ADDITIONAL CROSSING OF THE CLARENCE RIVER AT GRAFTON

Submissions report

OCTOBER 2014

Figure 3-1 Known records of the Three-toed snake tooth skink (Source: NSW OEH Bionet, 2013)

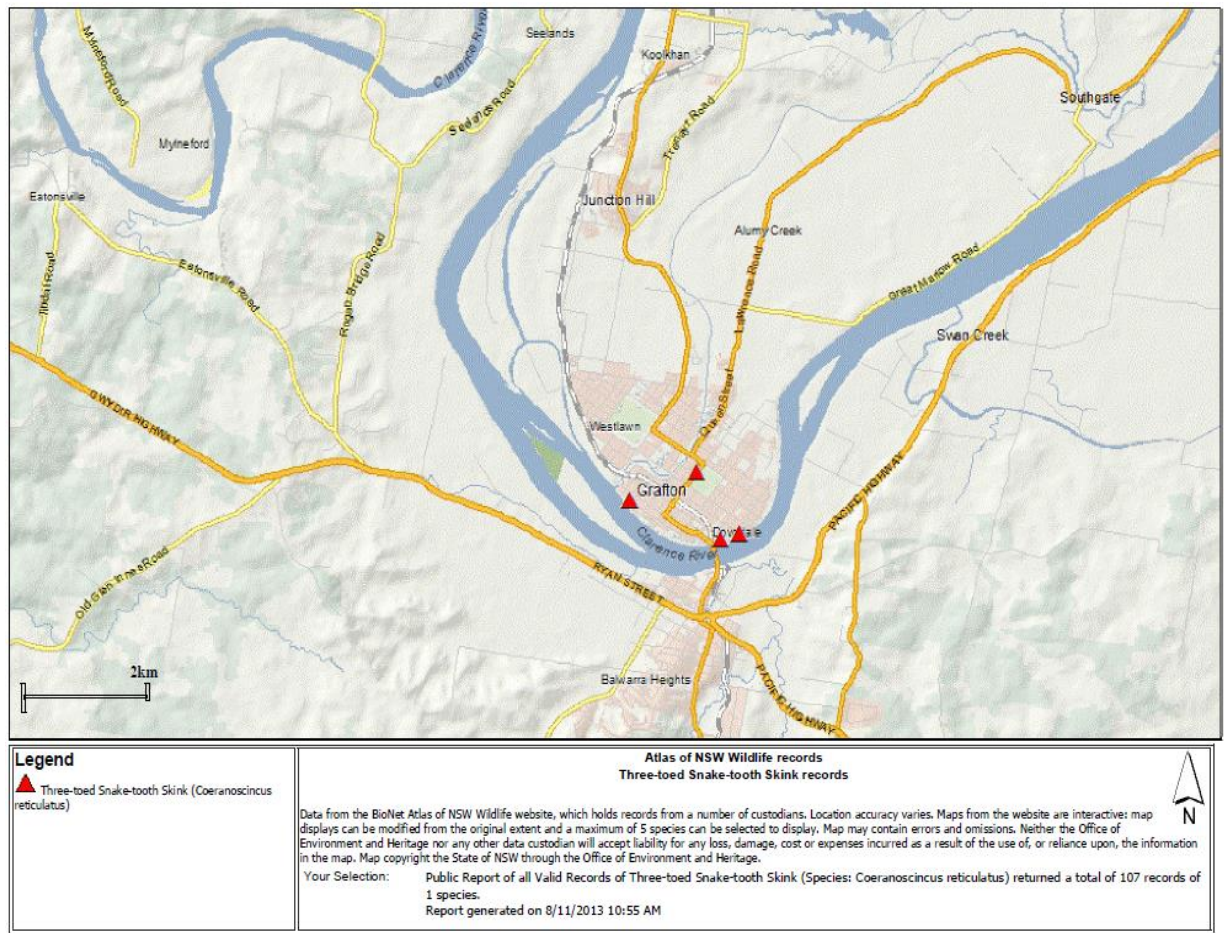
- The Targeted Threatened Species Survey Report for the Three-toed snake-tooth skink in Figure 1 of the Technical Paper shows the known records of the koala instead of the Three-toed snake-tooth skink. This should be corrected (OEH)

The map showing the known records of the Three-toed snake tooth skink presented in Figure 1 of the *Targeted Threatened Species Survey – Three-toed snake-tooth skink Coeranoscincus reticulatus* report in Appendix L of the EIS is not accurate. The correct map is presented in Figure 3-1.

Figure 3-2 Sensitive receivers within the project area for the air quality assessment

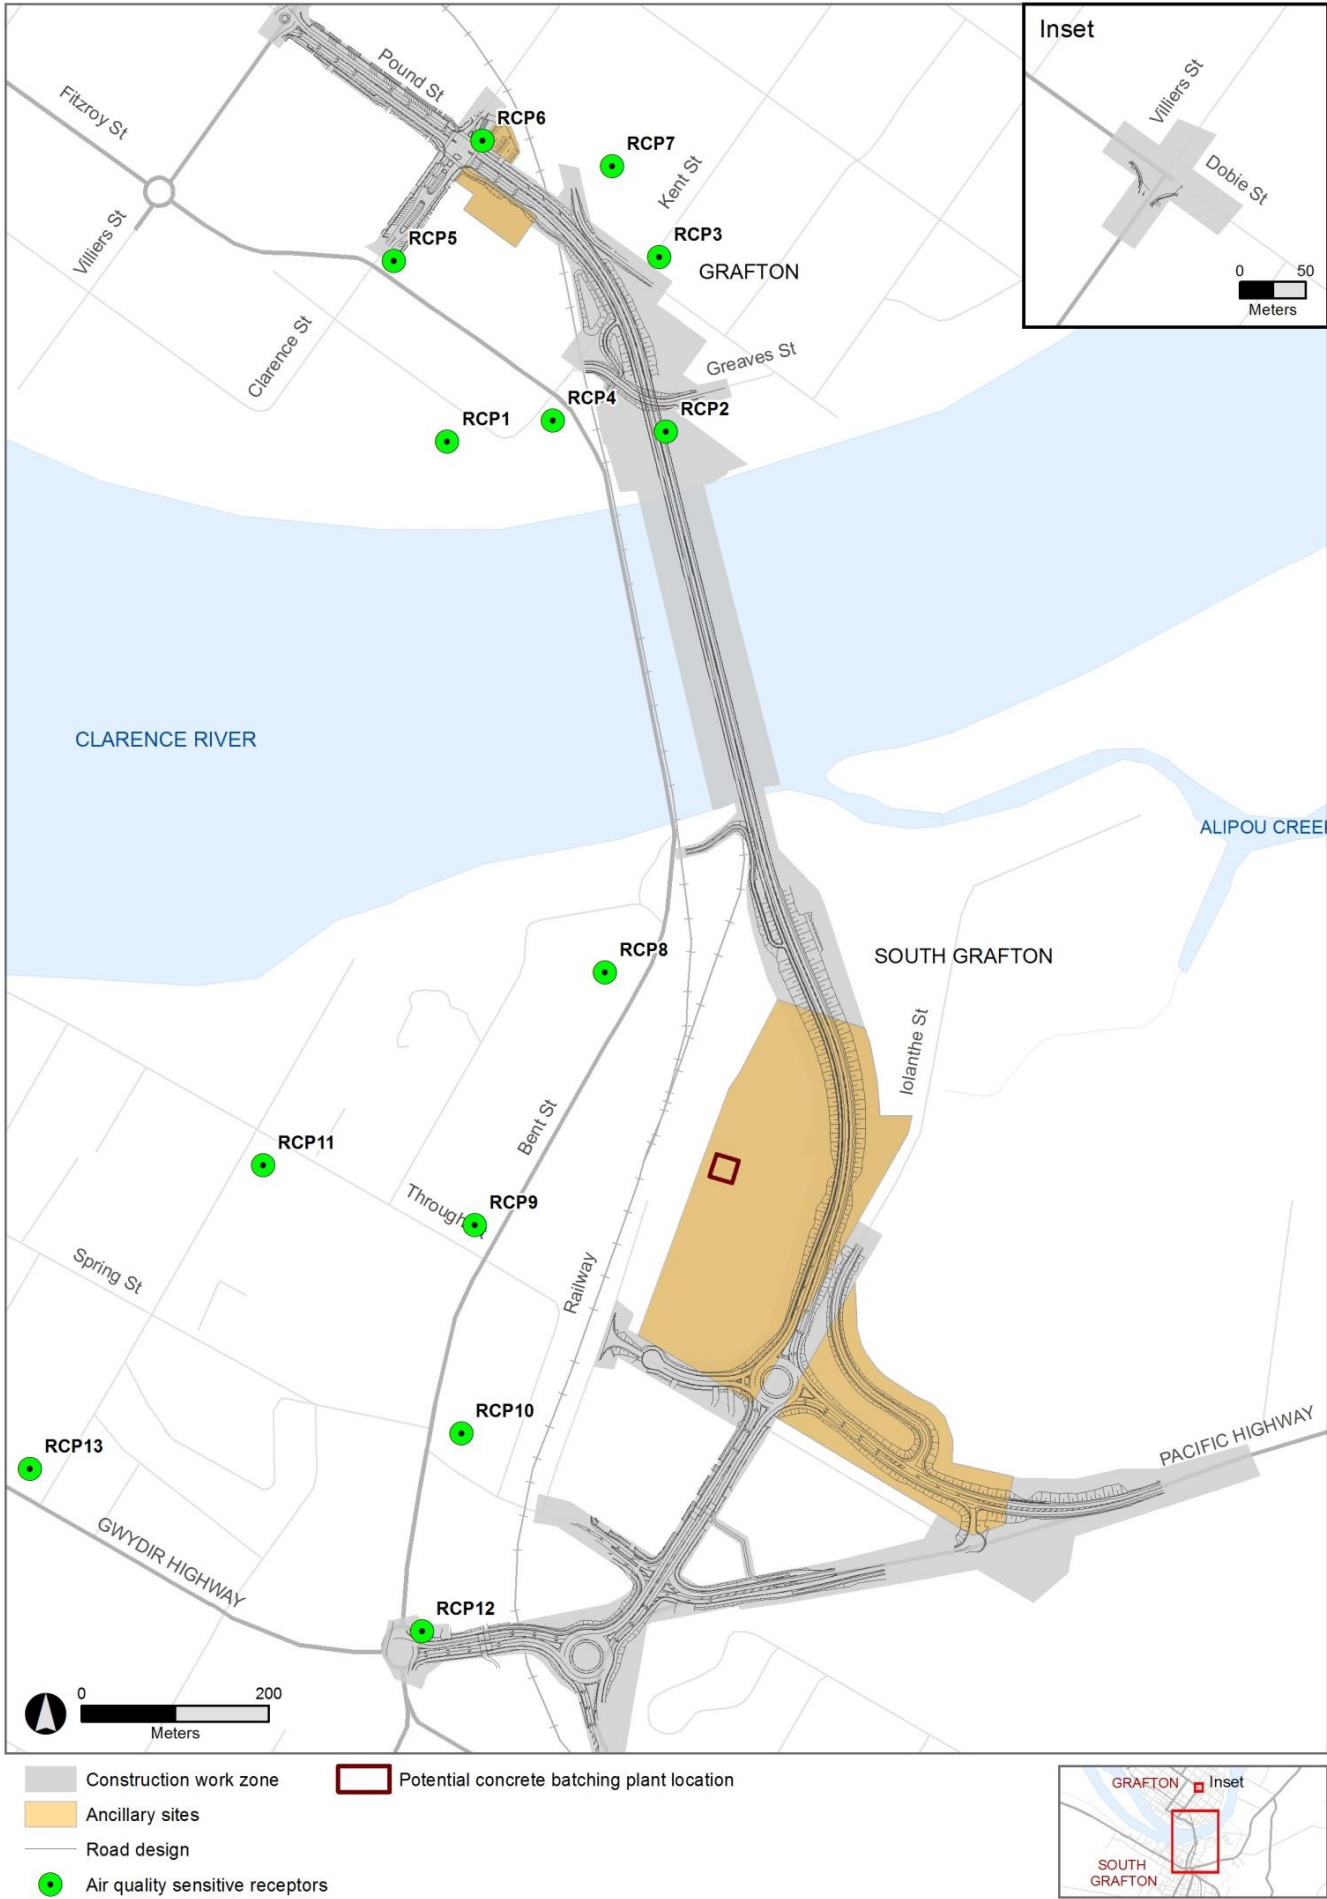
In regards to Table 8-82, Section 8.12 of the EIS main report, the measurement units for carbon monoxide should be mg/m^3 , not $\mu\text{g}/\text{m}^3$. Also, this table does not show the predicted operational air quality results for the Gummaney Aboriginal preschool sensitive receiver (this receiver is shown as RCP7 in Figure 3-2).

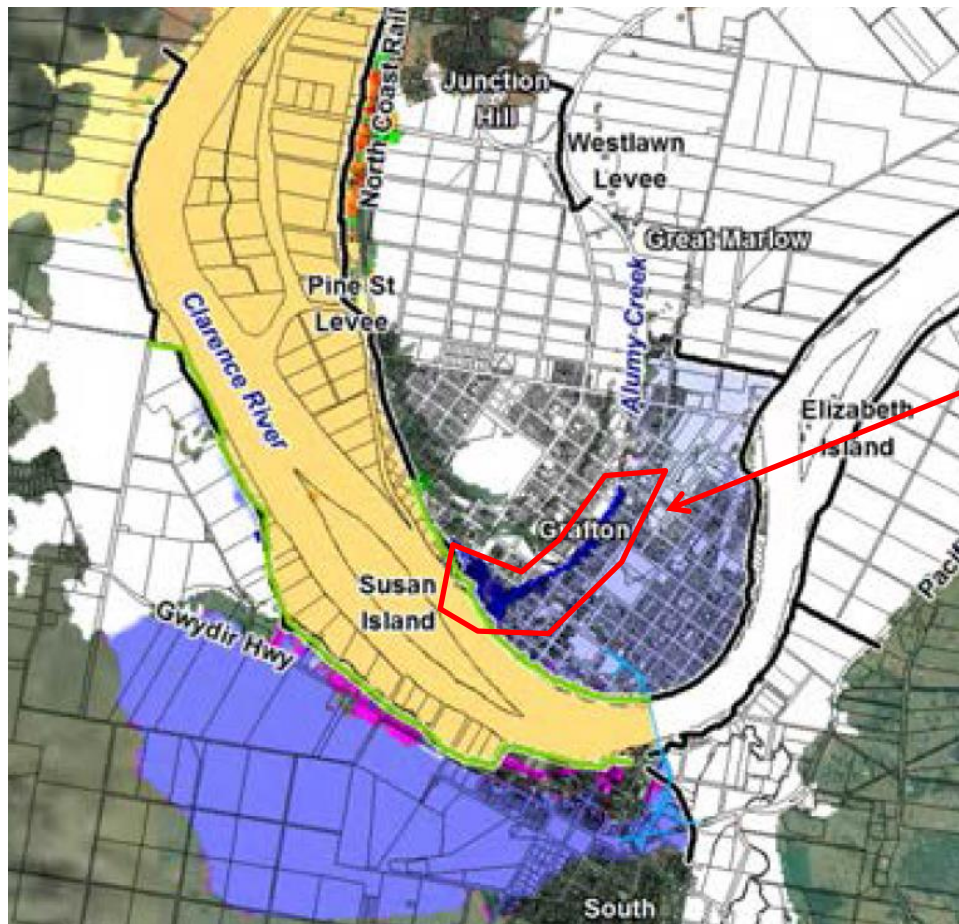
Preliminary testing has shown that representation of the proposed bridge by application of a form loss coefficient only (i.e. removal of the blockage factors) , as suggested by the independent reviewer, would result in a reduction of afflux of between 5mm and 10mm across the different events modelled (around a 10% reduction in each case). For the purposes of this assessment such a minor reduction would not change the overall findings of the study i.e. if predicted afflux for the 1% AEP design flood event would reduce from 100mm to 90mm this would not have a material impact on the proposed mitigation for the purposes of the EIS assessment.

We acknowledge that a verification of the assessed afflux using HEC-RAS would be worthwhile at the detailed design stage when the levee alignment and bridge designs are refined as any small changes which may result, and would not have affected the EIS conclusions, may assist with the design process.
